## DGM-69-25 – Addendum: Additional Public Comments Received

This addendum contains a copy of written comments received from the public on the Draft Residential Zoning By-law between Sept. 20, 2025 and noon on Oct. 3, 2025. Comments received from the public between July 2 and Sept. 19, 2025 are found in [Appendix G to staff report DGM-69-25](#).

## CZA Comments re: Burlington Residential Zoning Bylaw

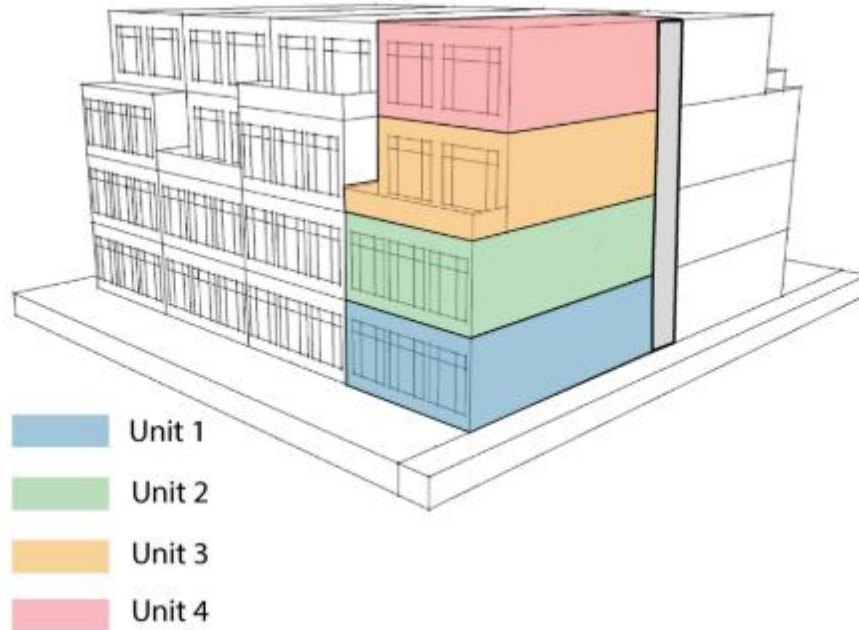
*CZA - I do not consider 2 units to be a cluster home and the words should be ” more than 2 units”*

**Dwelling, Triplex:** means a **Building** containing three principal **Dwelling Units**, where the units may be attached horizontally and/or vertically, and each unit has independent access either directly from the outside or through a common vestibule.

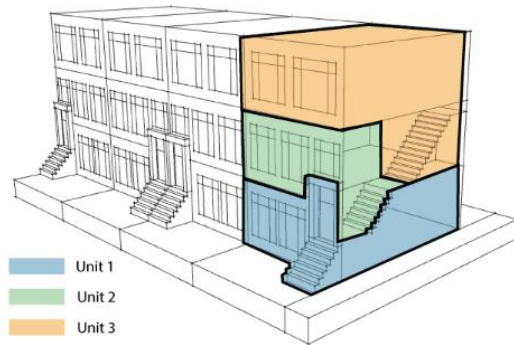
*CZA – this is an unusual depiction of a Triplex.....OBC may call this an apartment.*

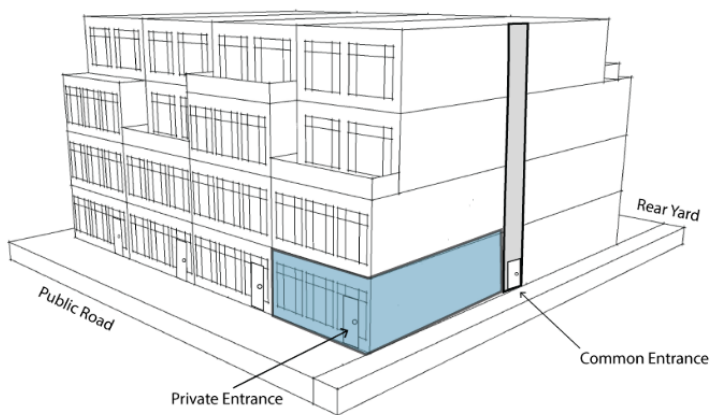
*CZA – Not sure how this drawing relates to Multiplex*

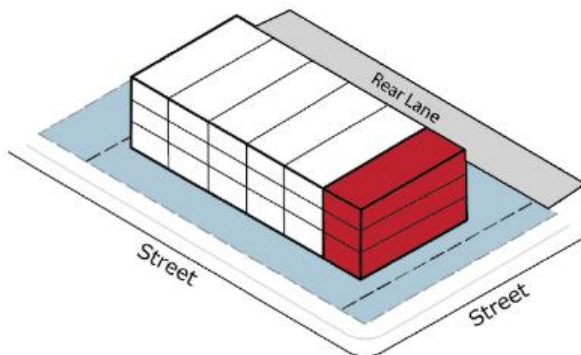
*CZA – I don't understand the difference between townhouse and apartments based on the diagrams.*

## 5.8 Daylight Triangles

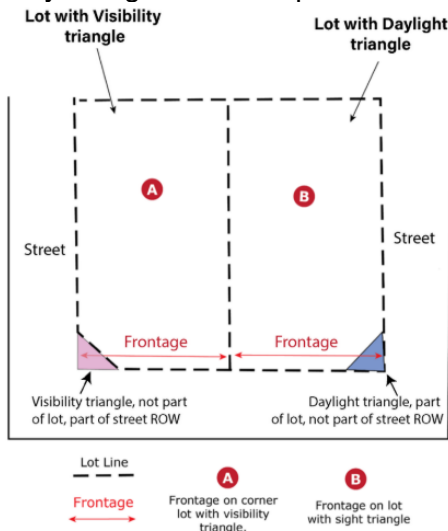
*CZA – the def seems at odds with the diagram*
